## City of Sebastopol Design Review Board Staff Report

Meeting Date: April 18, 2018  
Agenda Item: 8A  
To: Design Review Board  
From: Dana Morrison, Assistant Planner  
Subject: Continuation of Major Design Review  
Recommendation: Approval with Conditions  
Applicant/Owner: Christopher Jackson / Seismic  
File Number: 2018-27  
Address: 6700 Sebastopol Avenue  
CEQA Status: Categorical Exemption: Section 15301: Class 1  
General Plan: Light Industrial  
Zoning: M: Industrial

**Findings for Approval- Design Review**  
**Major Design Review**  
**Application Number 2018-27**  
**Approval to redesign exterior courtyards, improve landscaping**  
**at 6700 Sebastopol Avenue:**

SHEET NUMBER  
**DR6**

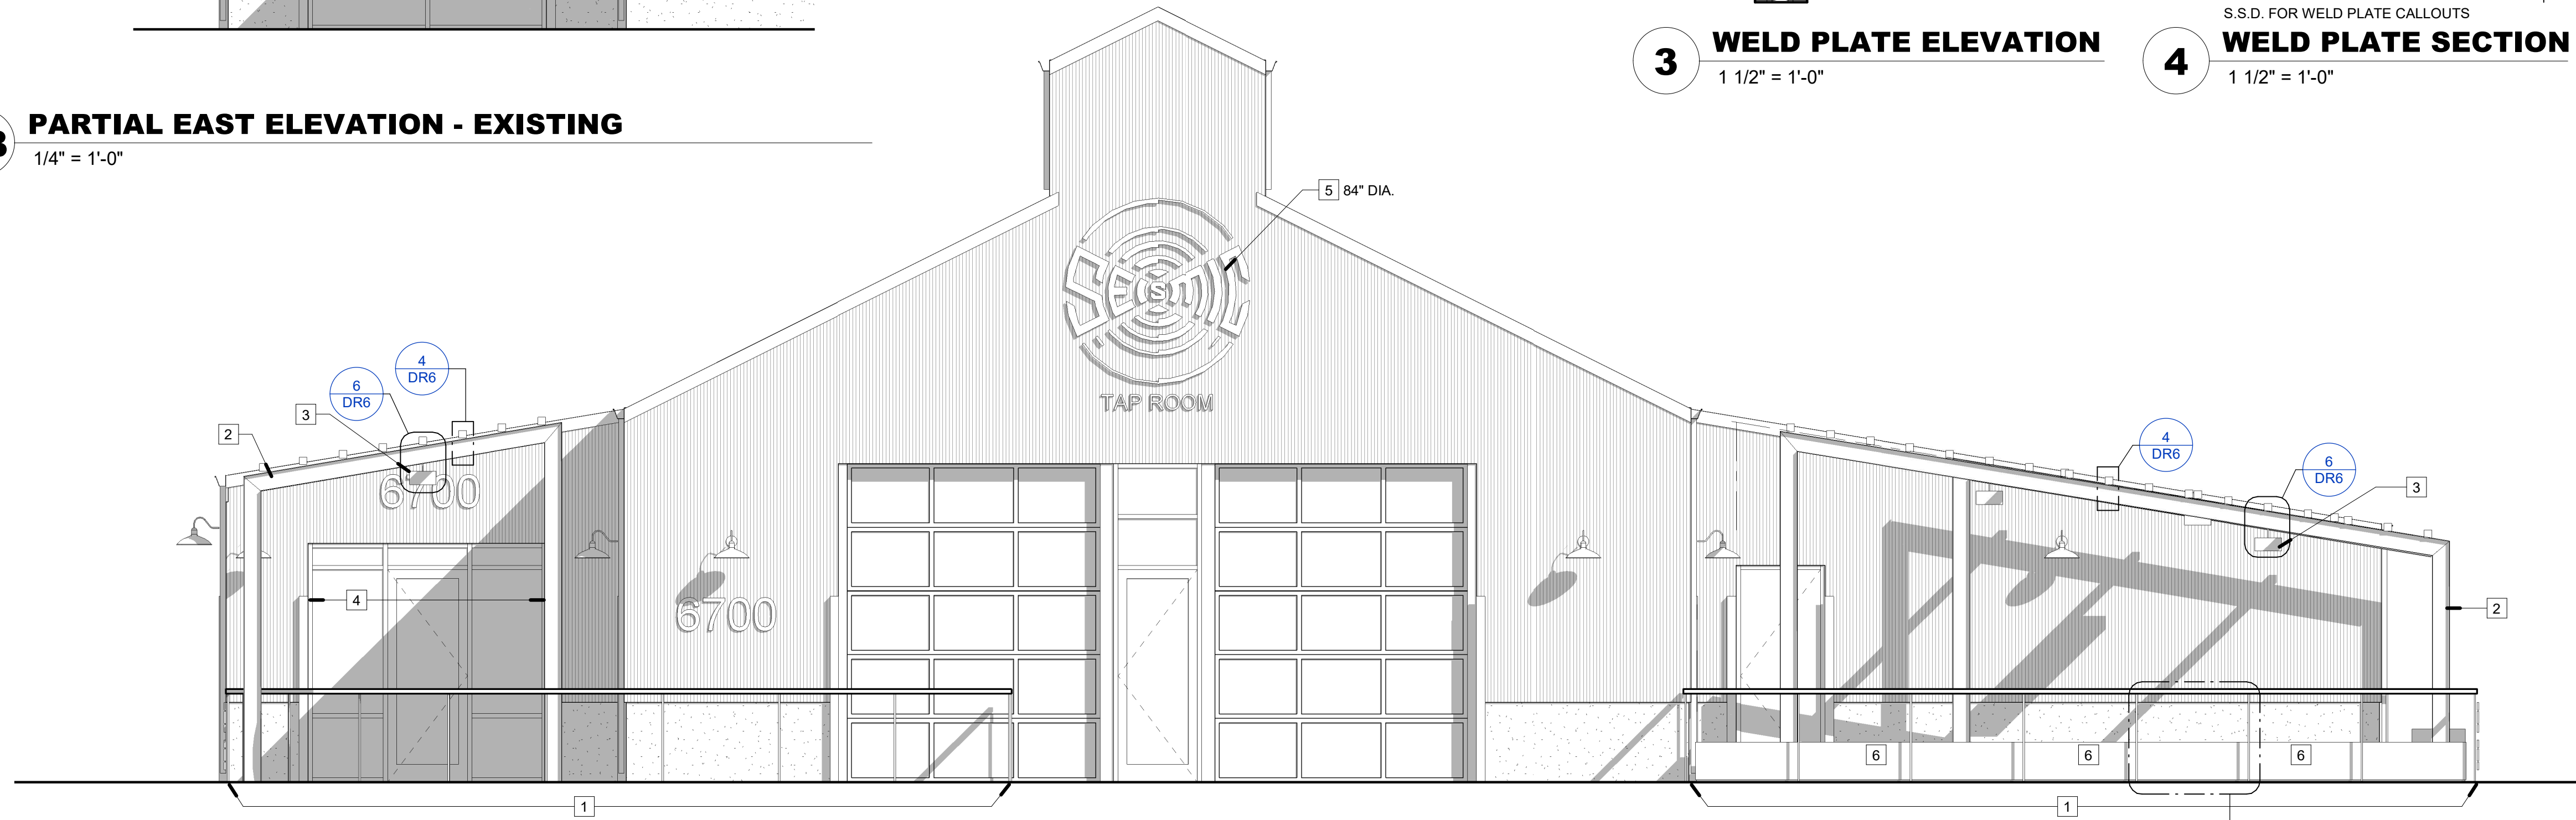
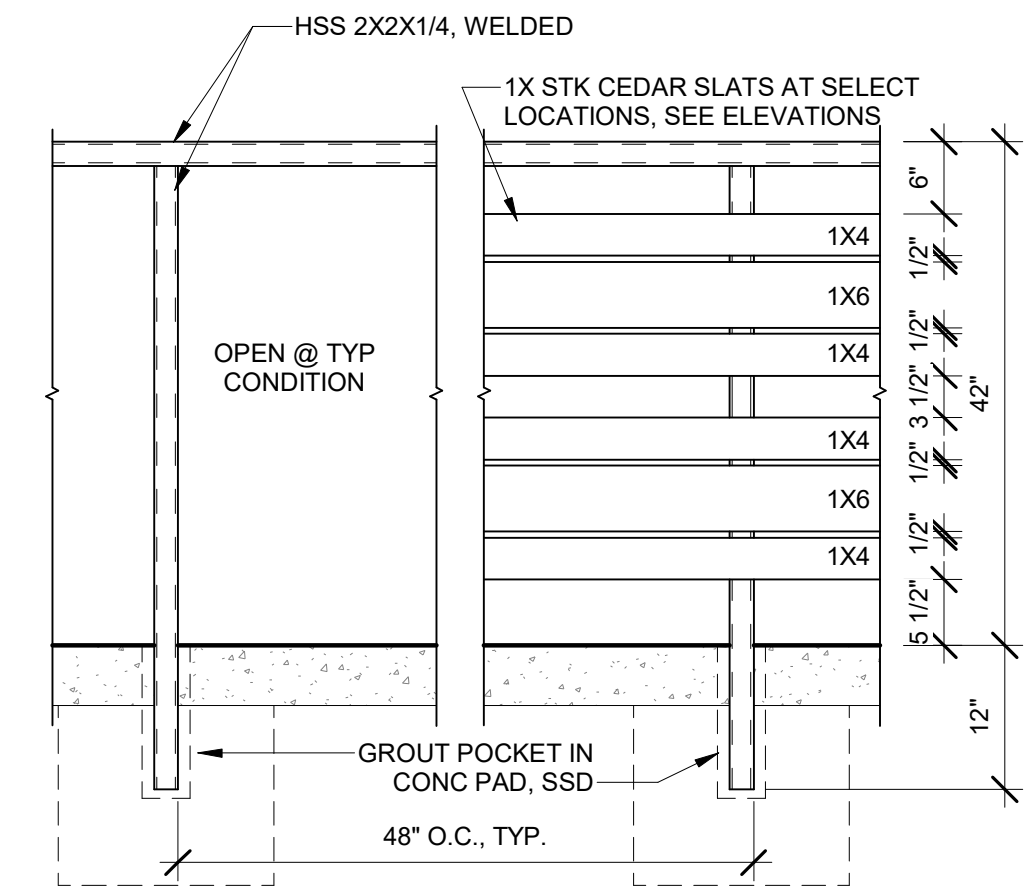
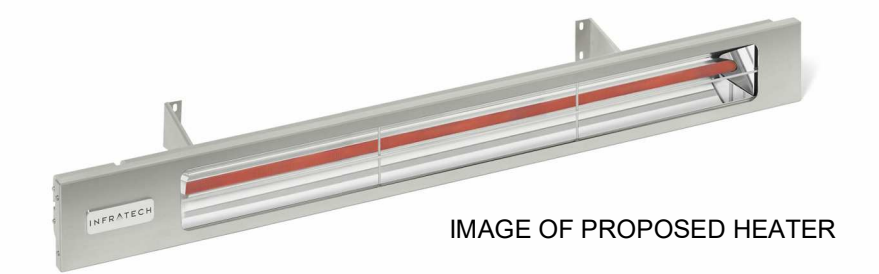
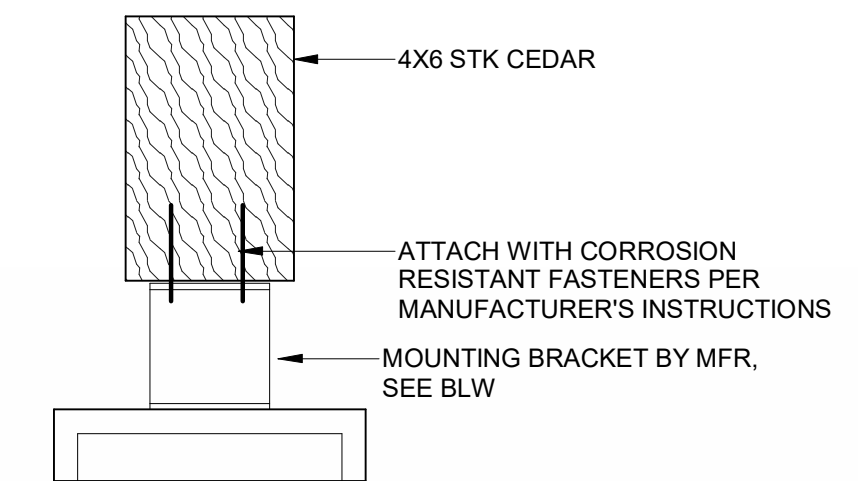
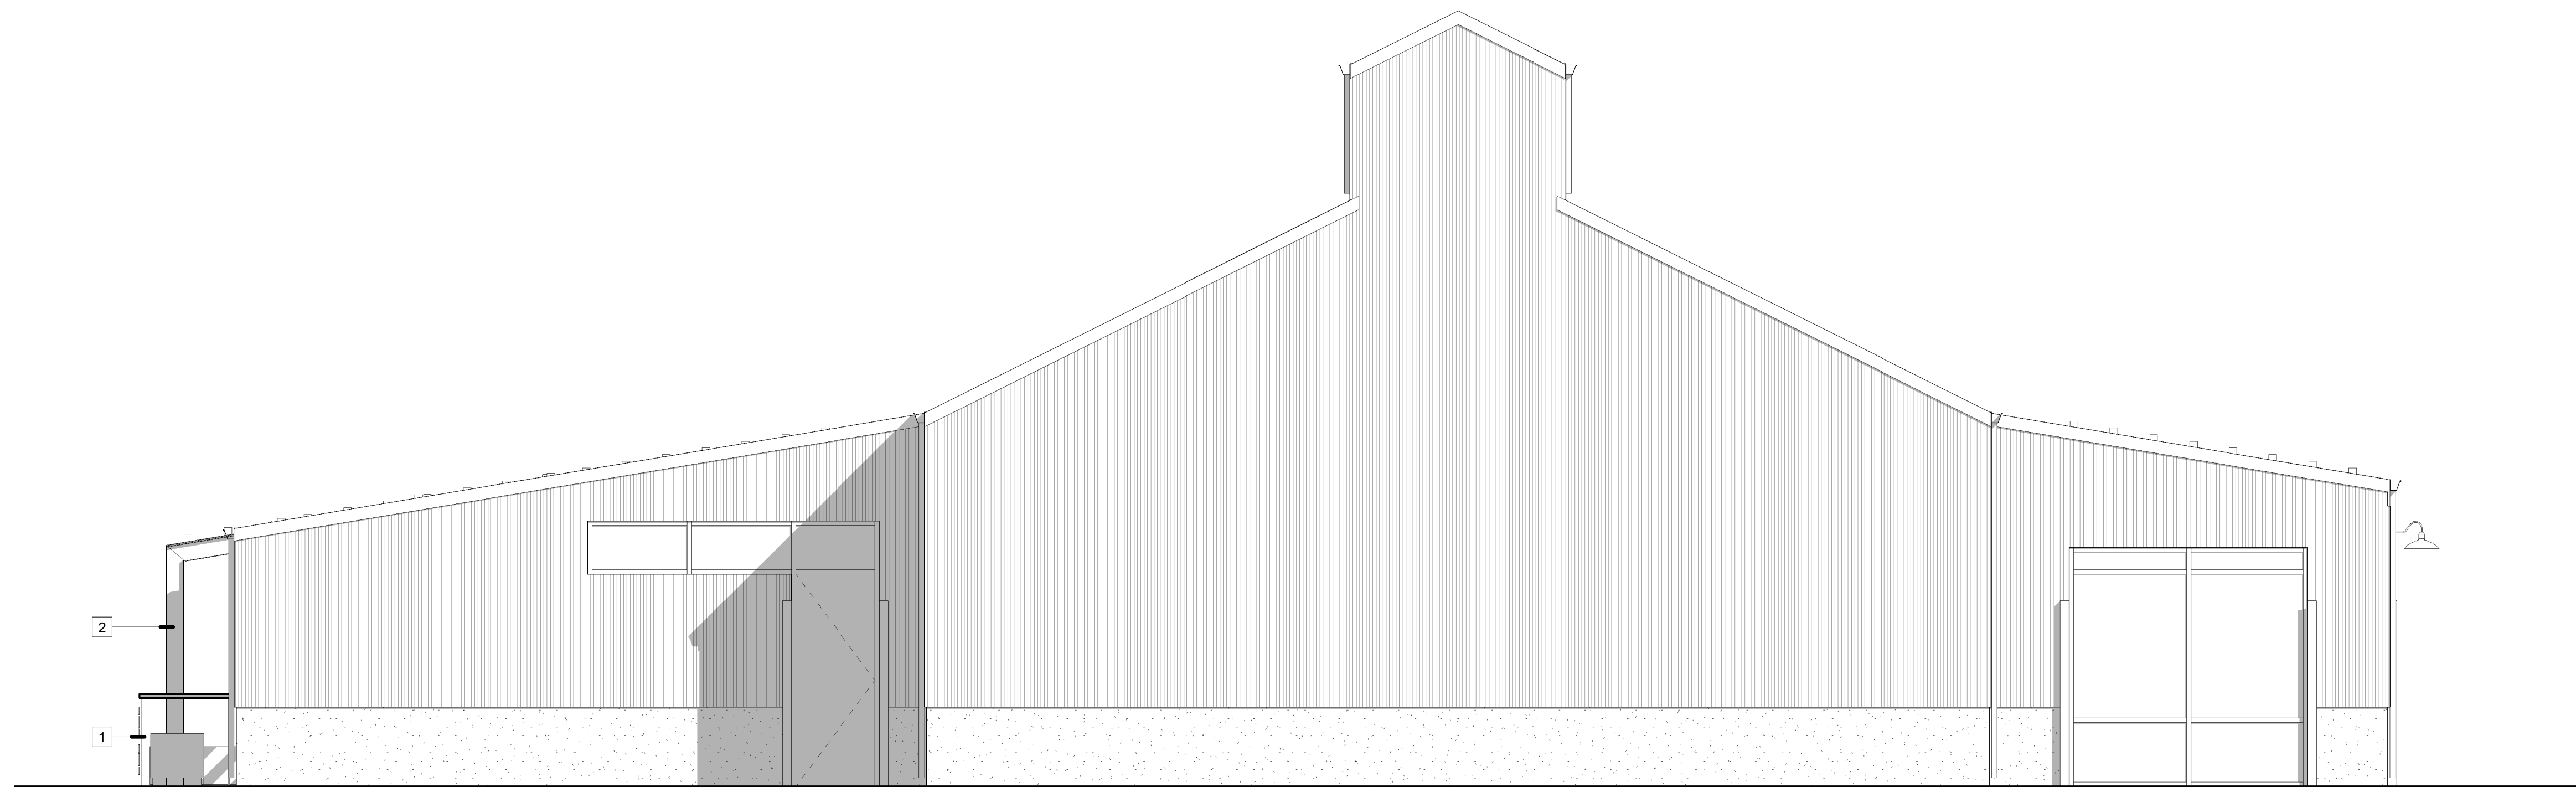
The project architect has also revised the plan submittals to address the details requested by the Board, which included details regarding:

- the anchorage, sizing and spacing of the pergolas (roof and supports)
- the anchorage, sizing and spacing of the railings
- how the heaters will be hung
- addition of 5 square feet of signage reading 'Tap Room' to the sign facing Morris Street.

SHEET NAME  
**SIGNAGE**

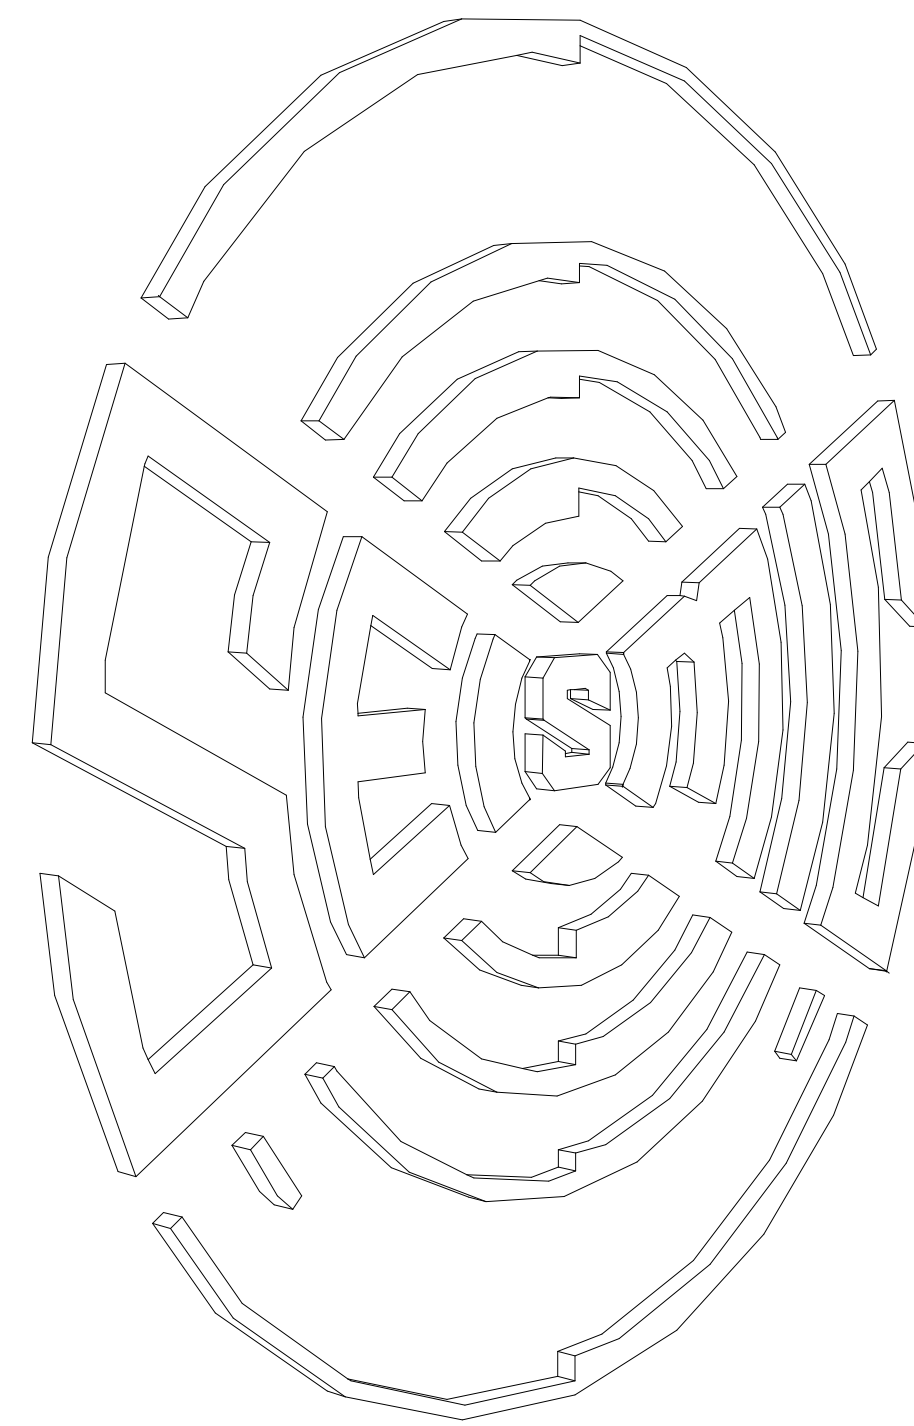
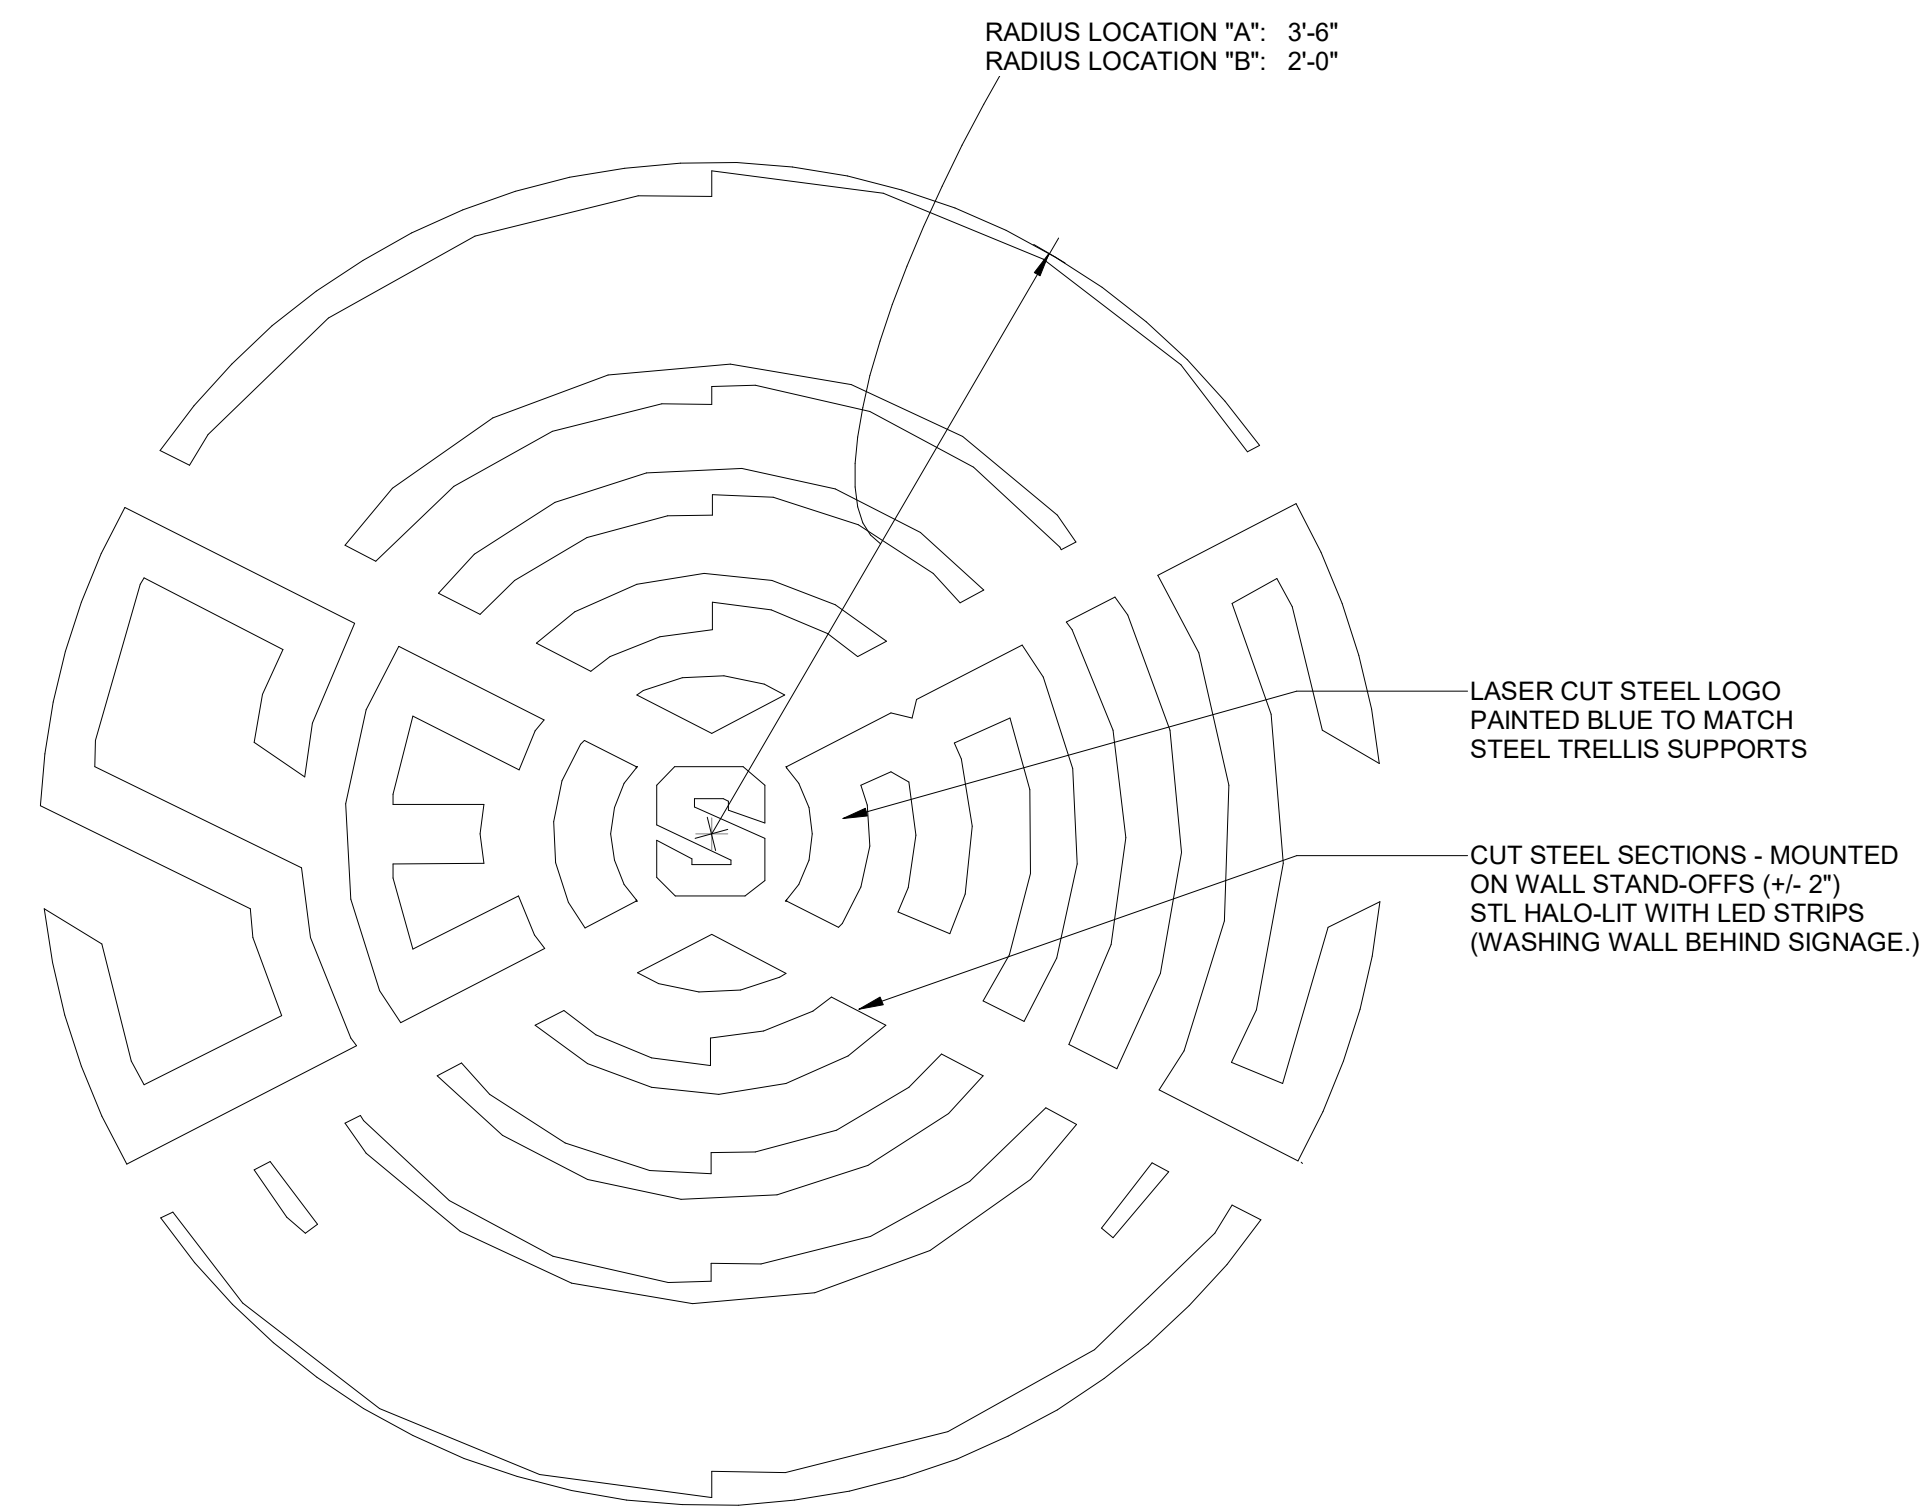
1. That the applicant consult with the City Arborist, Becky Duckles (707.829.0555) for all work being done on the concrete pad near the Bunya-Bunya tree; to ensure that the tree's roots are not impacted by any of the proposed work.
2. That the applicant revise the plans to show details regarding:
  - the anchorage, sizing and spacing of the pergolas (roof and supports)
  - the anchorage, sizing and spacing of the railings
  - how the heaters will be hung.
3. The Board also requested material samples, which the applicant has stated will be brought to the next scheduled meeting.
4. The Board also suggested that the applicant label the signage as Halo-lit and add the words Tap Room to the sign.
